wężyk do pompowania kół (średnica gwintu 8mm) Makita TE00000638

Y08765

Title	Change of Motor assembly with Air pipe assembly
Model	MP100D
Country	All countries
Description	[1][2] Air pipe assemblies for production have been unified to ø6mm thread type. [3][4] Motor assembly for production have been changed according to [1][2]. Note: There is no difference in performance between ø6mm thread type and ø8mm thread type. However, the repairs are different. See below.

ø8mm thread ø6mm thread

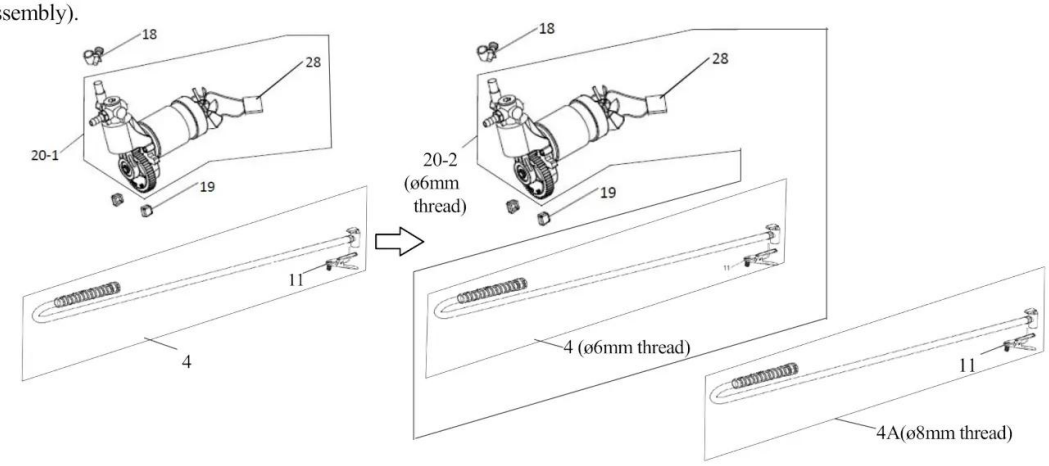
Current Air pipe assembly has either ø8mm or ø6mm threaded air pipe end as shown above.

New Air pipe assembly has the only ø6m threaded air pipe end.

Current Motor assembly has either ø8mm or ø6mm thread joint portion.

New Motor assembly has the only ø6mm thread joint portion.

Only Air pipe assembly wants to be replaced;
Check the thread diameter of the machine that the customer repairs, and order the same Air pipe assembly.

Motor assembly wants to be replaced;
Because of parts unification to ø6mm thread type, order the new Motor assembly (with ø6mm thread Air pipe assembly).
